Operator GP II Energy, Inc.
 Well Scanlon Draw 139 State #1
 Unit N Section 35 Township 18 Range 28
 API # 30-015-29384

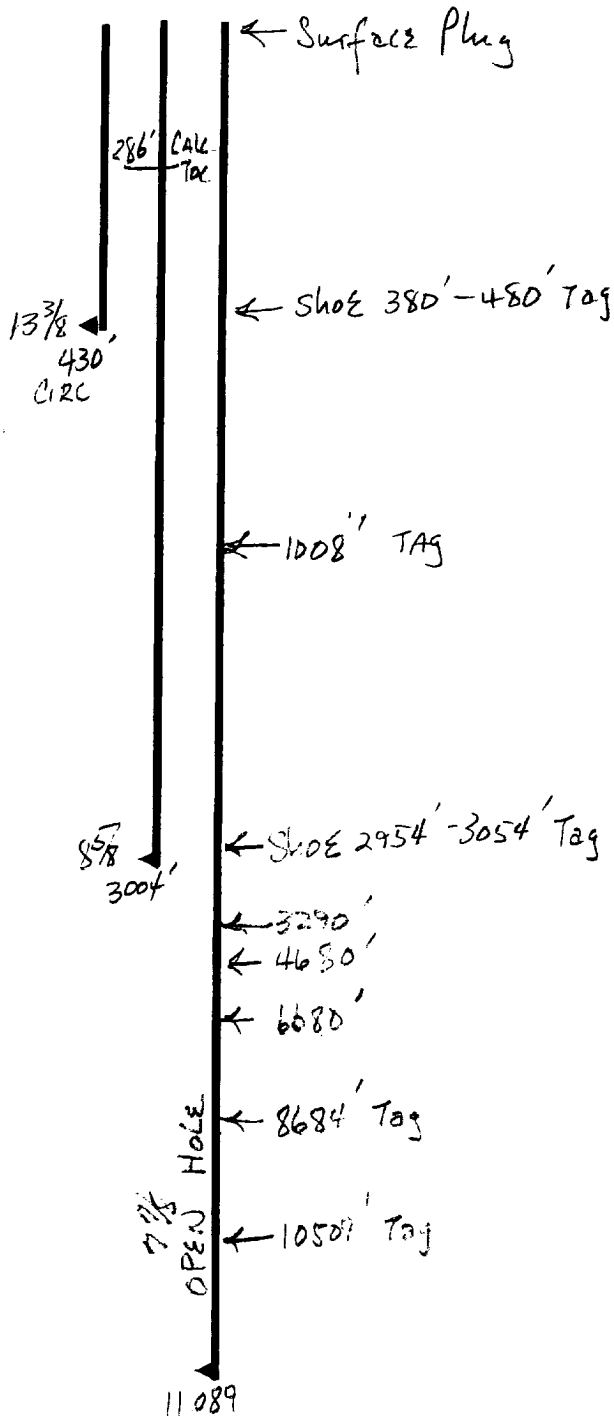
- * Contact OCD 24 hrs. prior to any work done.
- * Salt gel mud consisting of 10# brine with 25# of gel per barrel must be placed between each plug.
- * Install dry hole marker as per Rule 202.B.2
- * Plugs are to be set from point indicated up.
- * Plugs must not be less than 100' or 25 Sacks of cement, whichever is greater, unless specifically indicated.
- * Shoe and stub plugs will be 50' above and below shoe or stub and tagged.
- * Surface plug will be from 0' - 60'
- * Where plugs are required, cement must be placed inside and outside of all casing string(s) in the correct footage or sacks required, if no cement exists.
- * Plugs to be tagged will be indicated.
